Questions and Answers: REBID CH BOOTH HVAC UPGRADE 2024-15

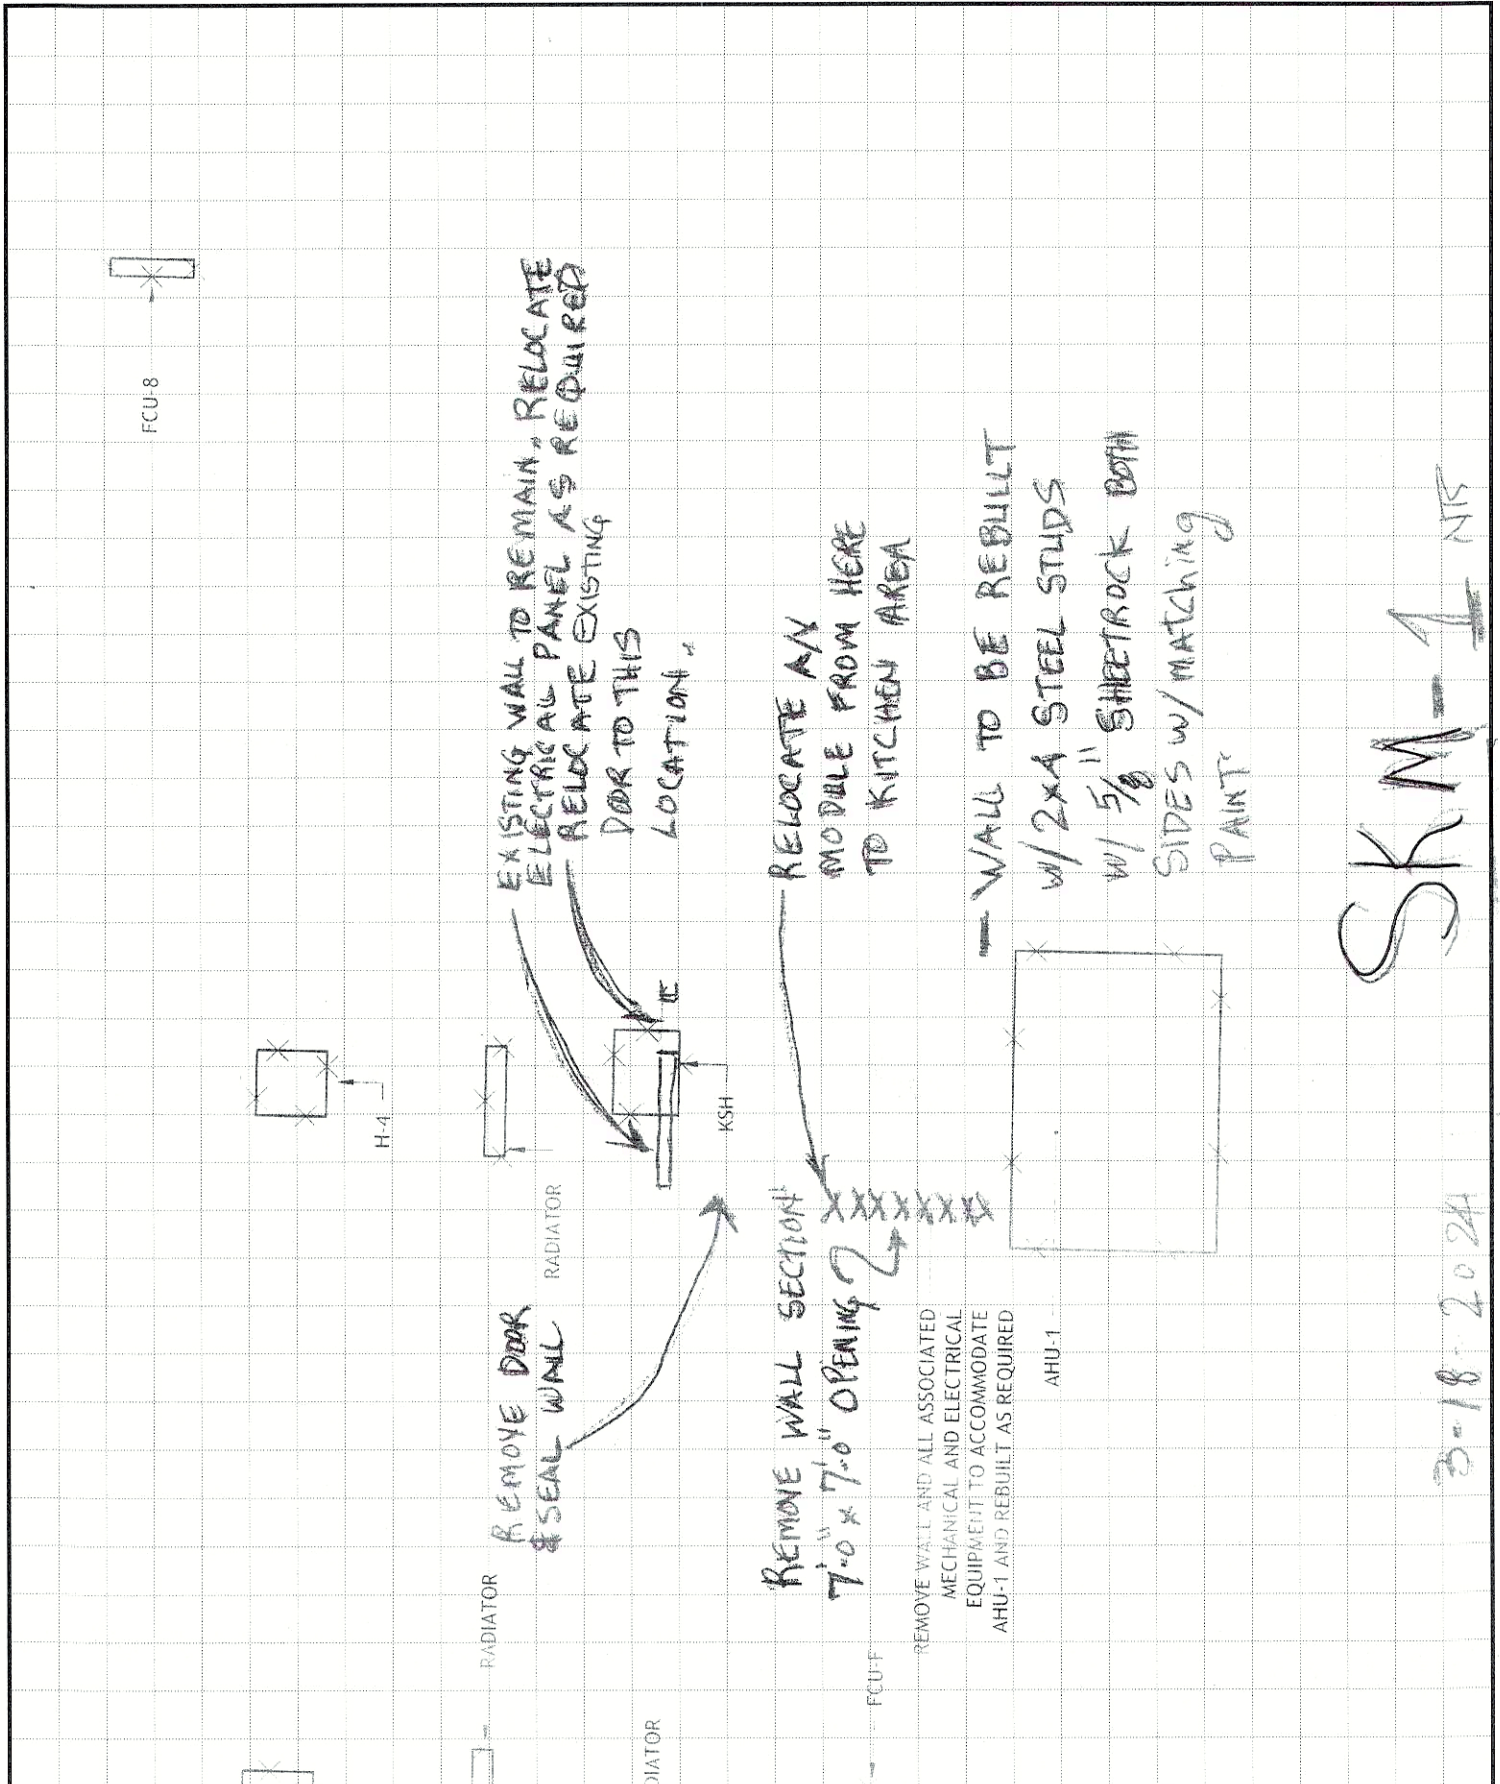
20. Architectural- Drawing M-001.00; Room 108 Storage. It was discussed that an existing wall would need to be demolished in order for the new mechanical equipment to fit in the room, however the wall is not shown to be demolished. Please provide a detail. Detail provided as SKM-1. Also see M-018 for additional details.

21. Architectural- Drawing M-001.00; Room 108 Storage. It was discussed that a portion of an existing side wall would need to be demolished in order for the mechanical equipment to fit through the door into the room; however the wall is not shown to be demolished. Please provide a detail. See SKM-1.

22. Architectural -Drawing M-001.00; Room 108 Storage. It was discussed that a new wall would need to be built in order for the new mechanical equipment to fit in the room, however the wall is not shown to be built. Please provide a detail and wall type. See SKM-1.

SKM-2

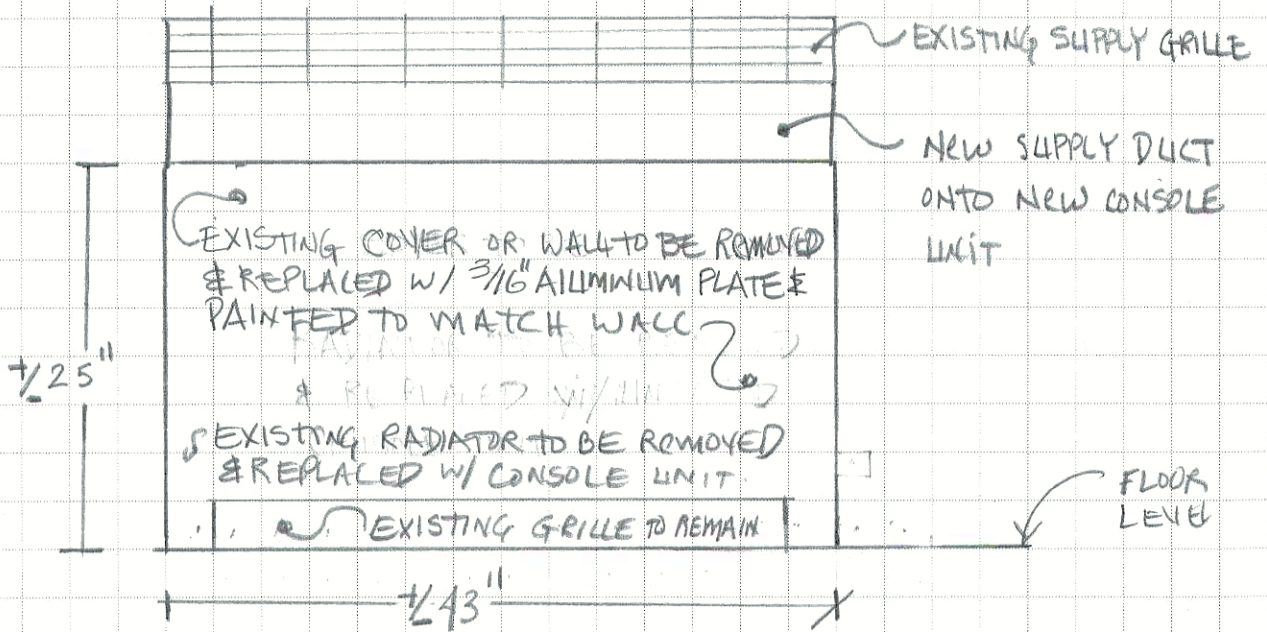
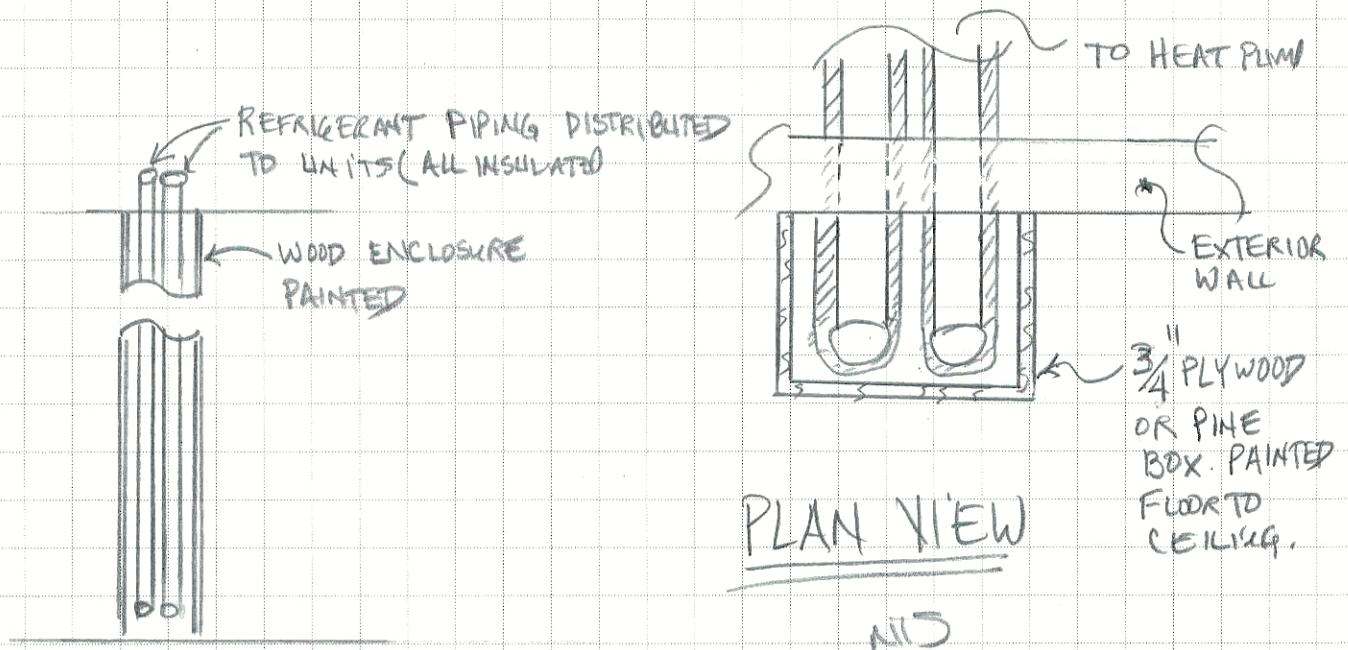
23. Architectural -Drawing M-001.00; In the condition where an uncased console is within the wall cavity such as in the corridor outside Conference Room 136. Please provide a detail to remove the existing wall and replace with new including wall finish and base condition. See SKM-2.

31. Architectural-Are refrigerant piping penetrations and risers to be cut in the existing wall and patched, exposed on the inside of the wall or is a shaft wall/soffit to be built? For example drawing M-008.00 HP-8 in Books/Circulation Desk on the lower level has a rise to the main floor. This repeats throughout the building including risers to the Upper level. Please provide a detail and section. **Refrigerant piping penetrations and risers in public spaces are to be run exposed inside the walls and protected by painted wood box. See SKM-2.**

SKM-3

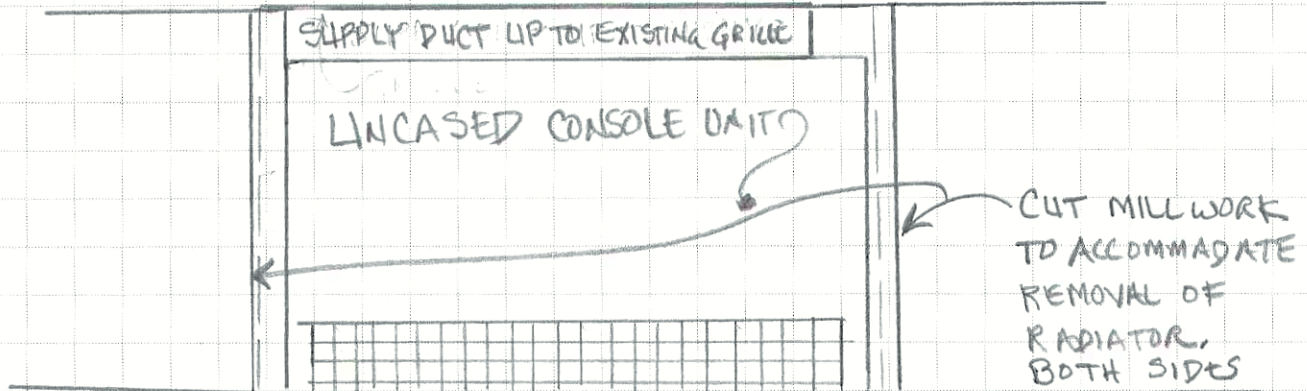
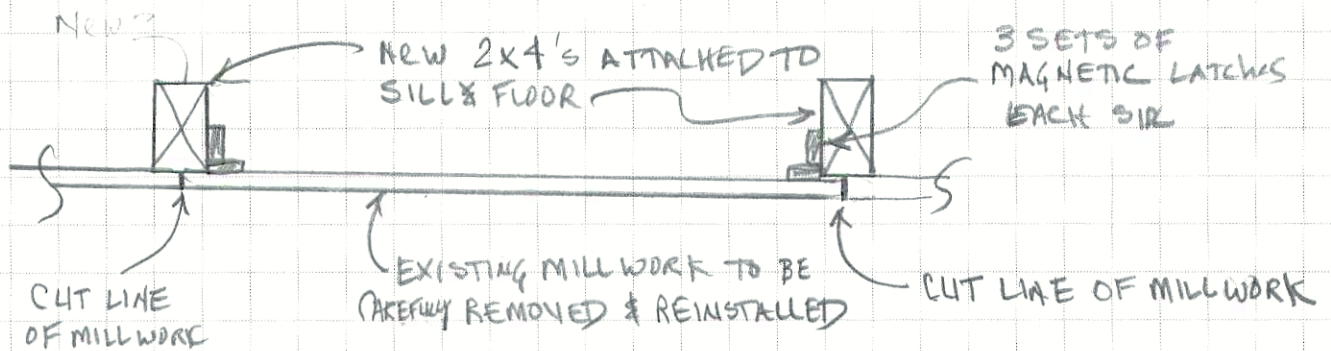
32. Architectural-Various units are installed in existing millwork. Is the intent to match existing? If so please provide a detail. **Intent is to cut millwork carefully to size to remove radiator and replace with console unit. Re-use cut millwork and provide structure and magnets. See SKM-3.**
